December 2, 2022

**RE: Stormwater Management Manual for Western Washington (SWMMWW)  
Preliminary Draft Package (October 2022)**

Preliminary Draft Comment Template – City of Everett Response  
City of Everett Comments on Figure 4: Flow Chart for Determining Requirements for Redevelopment

Figure 4: Flow Chart for Determining Requirements for Redevelopment

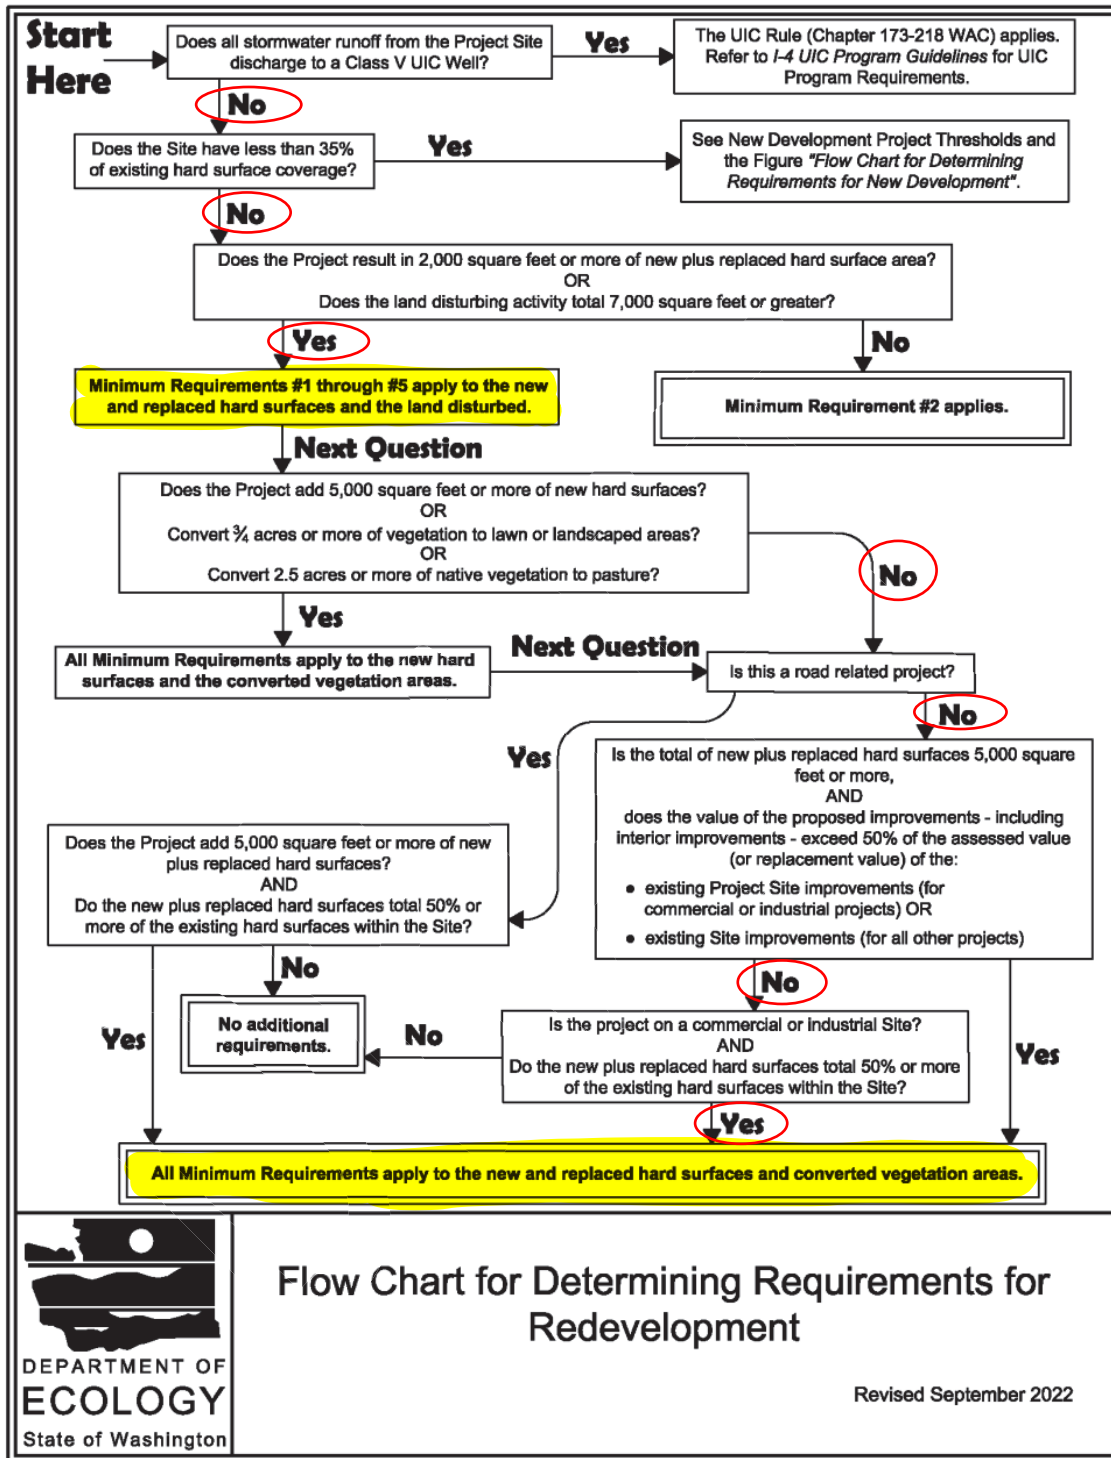
MS4 Permit: Appendix 1 (Phase I and Western Phase II)	For Figure 4: Flow Chart for Determining Requirements for Redevelopment, please define commercial and industrial projects. Clarify whether schools fall into these definitions.	City of Everett
SWMMWW Item 2: Climate Change Topic	Ecology's recommendations include using local future precipitation projections to size flow control facilities. The City of Everett worked with the University of Washington to produce a climate change adjusted time series that we might consider implementing as a standard. However, loading the time series into WWHM and performing design sizing is cumbersome at best. In order to require the use of the future data as a design requirement for development, we need to have an easily accessible way for all designers to use it. A couple of options that may work include: 1) Update WWHM with a user-friendly tool for importing alternate rainfall data. It would need to be something that was as simple as pushing a button and selecting a data file to work as a requirement for all projects. 2) Facilitate incorporation of local jurisdiction rainfall data into the published WWHM rainfall files so that users can select jurisdiction specific information from the drop-down. Currently, the process is not user-friendly to important outside data, and our concern is there may be erroneous import of that data.	City of Everett

MS4 Permit: Appendix 1 (Phase I and Western Phase II)	<p><u>In reference to Figure 4: Flow Chart for Determining Requirements for Redevelopment - "Is the project on a commercial or industrial site? And Do the new plus replaced hard surfaces total 50% or more of the existing hard surfaces within the Site?":</u></p> <p>As presented, the Figure 4 flow chart could be construed to say that any project which replaces 50% or more of the existing hard surface must apply MR 1-9. Presumably, the intent is to limit this to projects with new/replaced hard surface exceeding 5,000 SF, but it does not actually say that. (See our attached flow chart notes for more details.)</p>	City of Everett
MS4 Permit: Appendix 1 (Phase I and Western Phase II)	<p>How well do the available runoff treatment technologies, particularly proprietary BMPs, scale to treating smaller drainage areas (for the proposed reduction to the MR #6 threshold from 5,000 sf to 2,000 sf)?</p>

Assume a project is being constructed on a site with 8,000 SF of existing pavement and will replace 4,500 SF of hard surface.

Result: The project is required to address MR 1-9 even though it only replaces 4,500 SF of hard surface. With the changes to the MR 6 specific threshold this project could easily be required to provide WQ treatment. There are likely very few commercial/industrial sites that are small enough for this to be an issue, but it is possible. Coffee stand?
